Subject: DELINEATION REPORT PROVIDED BY ELOS DATED 12-22-2014

Parish - Livingston

Section - 3

Acreage - 24±

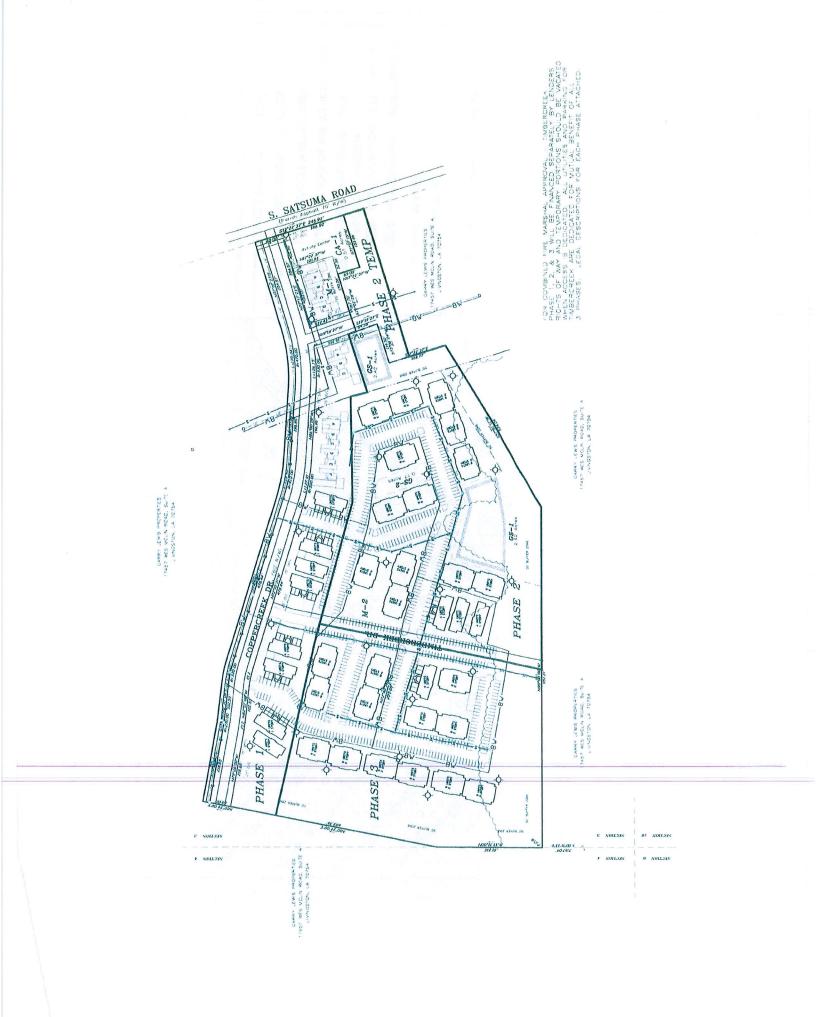
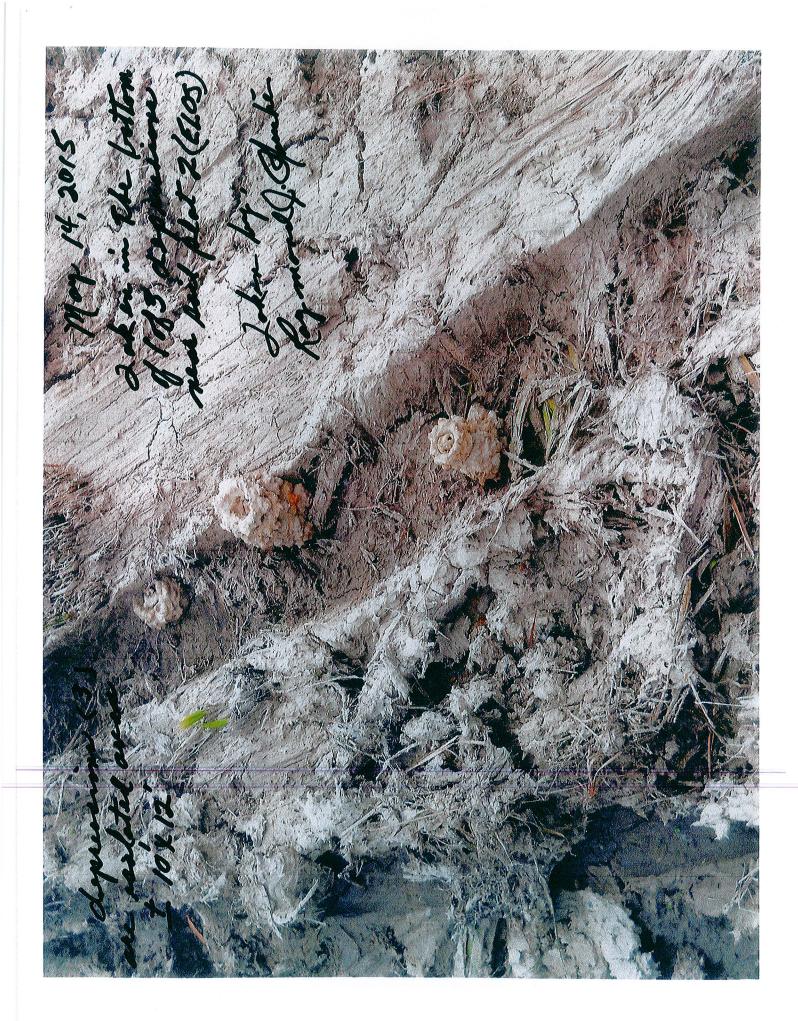
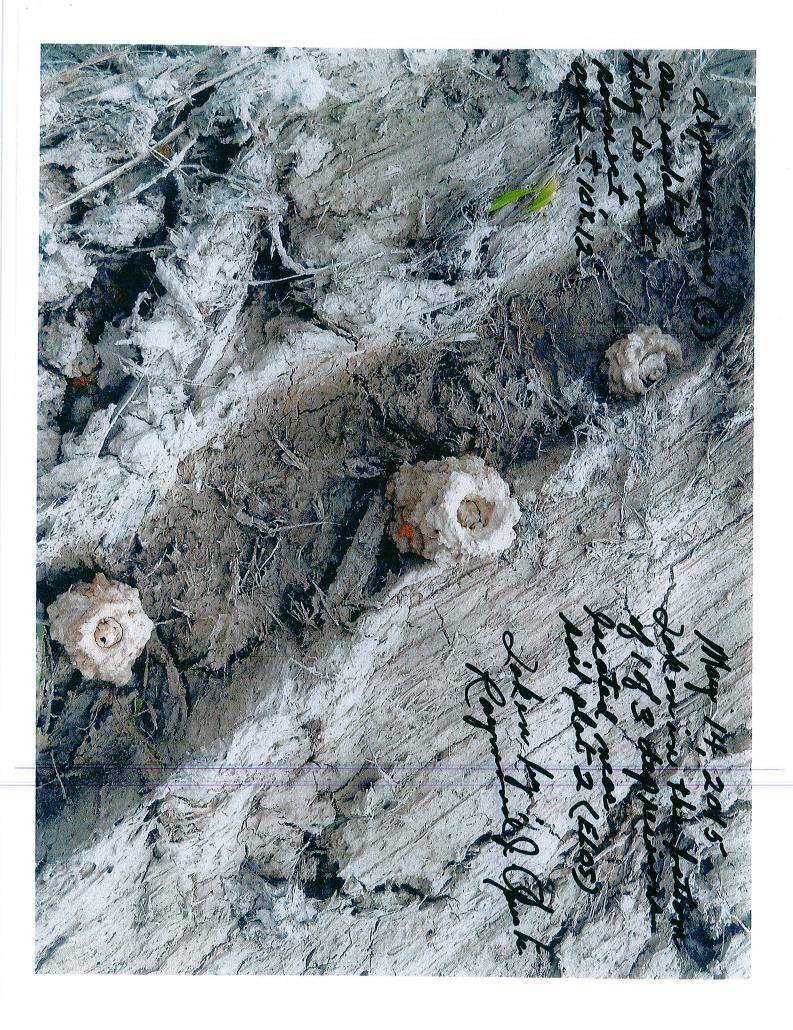
The Three (3) subject depressions on the following photos were investigated as potential isolated wetlands.

Their origin is from logging machinery. They are not manmade and they are not natural. The surface grey color is from dragging tree tops. The photos show the color and property of Satsuma ridge soil type being brought to the surface by crawfish. These depressions are absent the required soil type and the required vegetation is absent.
